Recall Bulletin**RCL-06-0--****DNA**

To: Service Manager
Dealer Principal, North American Ducati Dealer Network**Subject: Fuel Pump – Fuel Sending Unit Wiring Cables****Models: ST3 – ST3ABS MY 2006****Important:**

Subject: Service Instructions for RCL -06-TBD

Models: ST3 – ST3ABS MY 2006

PICTURE 1

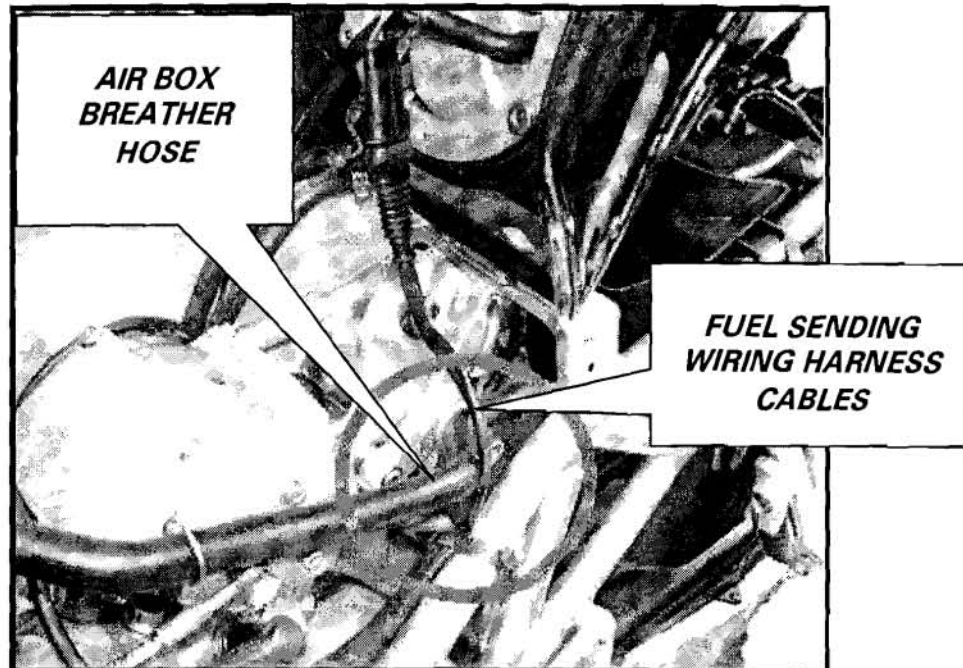
Lift the fuel tank and check that fuel pump cable is routed outside of the air box breather hose (as shown in picture 1).

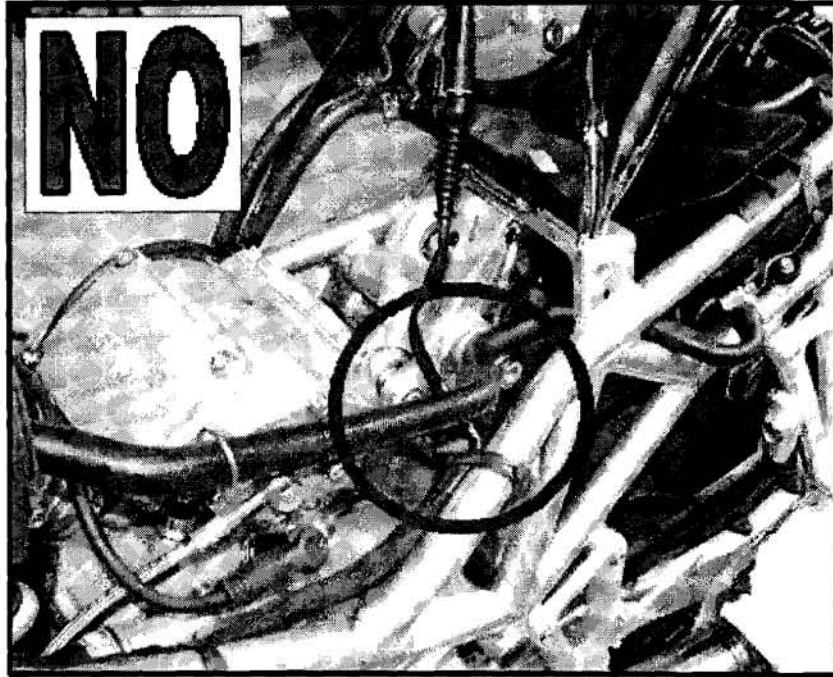
Picture 2 shows incorrect cable routing that shall be rectified and set as shown in picture no. 1.

It is necessary to reposition it because cable could touch the vertical cylinder exhaust pipe.
